**ZONING CHANGE REVIEW SHEET**

CASE: C814-2018-0121 -- 218 South Lamar

TO: PUD

ADDRESS: 218 South Lamar Boulevard Southbound

4-Lane Divided, 60' Curb-to-Curb  
Back-of-Curb Condition F  
Barton Springs Road to Riverside Drive

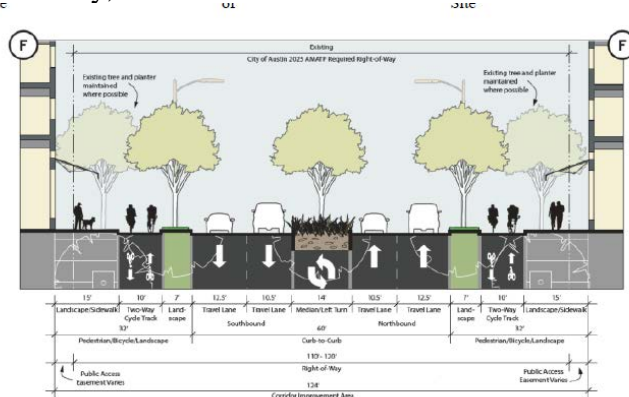
TR2. Include the below streetscape in the land use plan. Contact this reviewer for a more legible copy of it if necessary. This project is adjacent to a street that has been identified in Austin's Corridor Mobility Program (S Lamar). The sidewalk and bicycle facilities shall comply with the required cross-section at the time of the site plan application. The cross section that will be required is shown below. Find additional information about the Corridor Mobility Program here: <https://data.austintexas.gov/stories/s/Corridor-Mobility-Program/gukj-e8fh/>. Any proposed curb relocations on S Lamar requires coordination with the Corridor Planning Office and Bicycle Program. The cross section will include a 7' planting zone with street trees, a 10' two-way cycle track, and a 15' clear zone all behind curb. Additionally, a protected intersection will be required at Toomey, to be reviewed at the time of Site Plan.
